Amendments to the Drawings:

REMARKS

The Office Action dated February 17, 2005 has been carefully considered. Claim 9 has been amended. Claims 1, 2, 4-17 and 19 are in this application.

Annotated Sheet Showing Changes

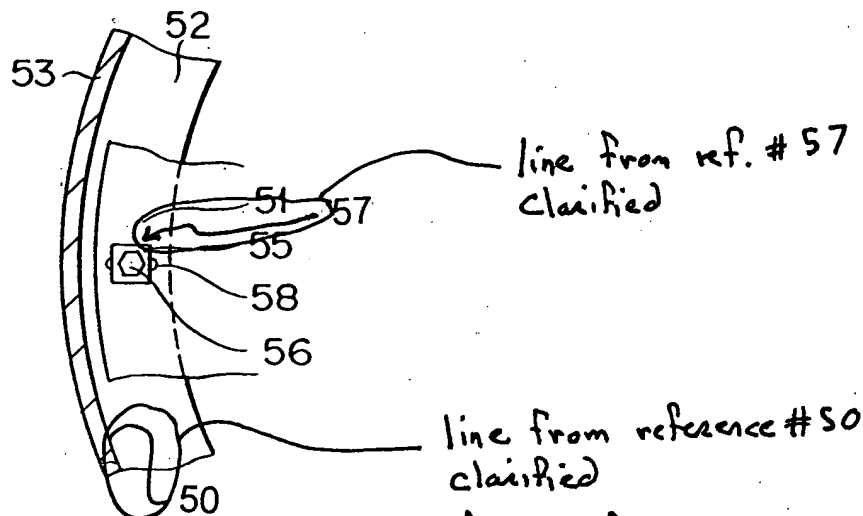
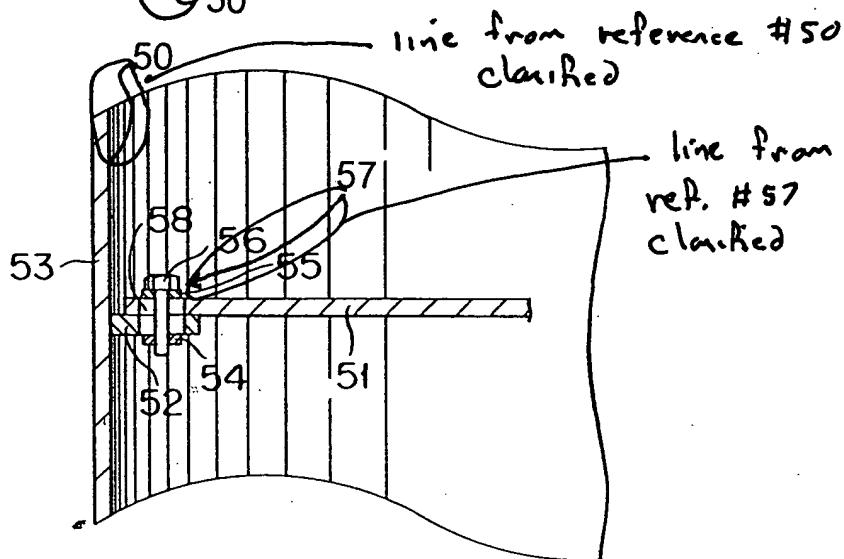
The attached sheet of drawings includes changes to Figs. 5a, 5b and 5c. This sheet replaces the previous sheet including Figs. 5a, 5b and 5c. Reference lines for reference numbers 50 and 57 have been clarified.

The Examiner indicated that both 57 and 55 and 50 and 52 appear to be pointing at the same thing. Applicants revised the drawings and clarified the reference lines and submit that 55 points to a washer, while 57 points to a fixing part which is a general area, including, bolt 56, washer 55 and nut 54. Applicants submit that 52 points to support ring 52, while joint part 50 points to the joint between support ring 52 and inner wall 53.
